SAFETY EVALUATION BY THE OFFICE OF NUCLEAR REACTOR REGULATION

PRESSURIZED THERMAL SHOCK EVALUATION

FLORIDA POWER AND LIGHT COMPANY

ST. LUCIE UNITS 1 AND 2

FIGURE 10 - HISTOGRAM OF WESTINGHOUSE DESIGNED WELD DATA

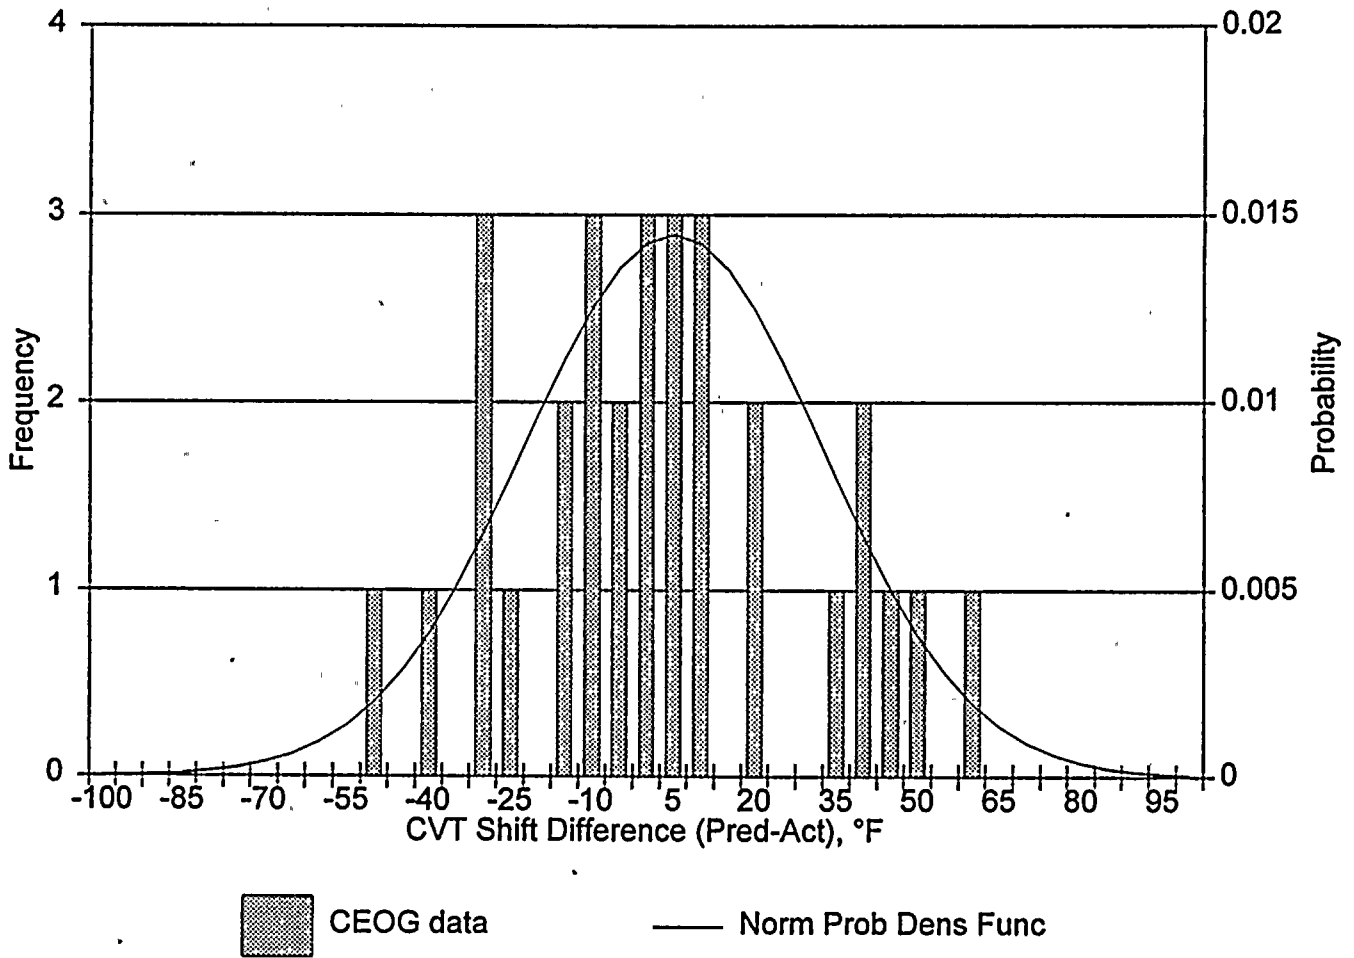
Figures 2-7, 9 and 10 present the histograms of the CEOG CE and W plate and weld data. These figures indicate the frequency of a given value as well as the normal probability distribution based on the calculated mean and standard deviation. Figures 8 and 11 present the combined CEOG CE fabricated, CE and W designed plate and weld data, respectively.

Based on the statistical analysis, the staff concluded that there is no significant difference or bias between the CE fabricated, CE and W designed surveillance data. Therefore, surveillance data from CE fabricated, CE and W designed vessels will, on average, be representative of each other for vessels fabricated in the CE Chattanooga facility.
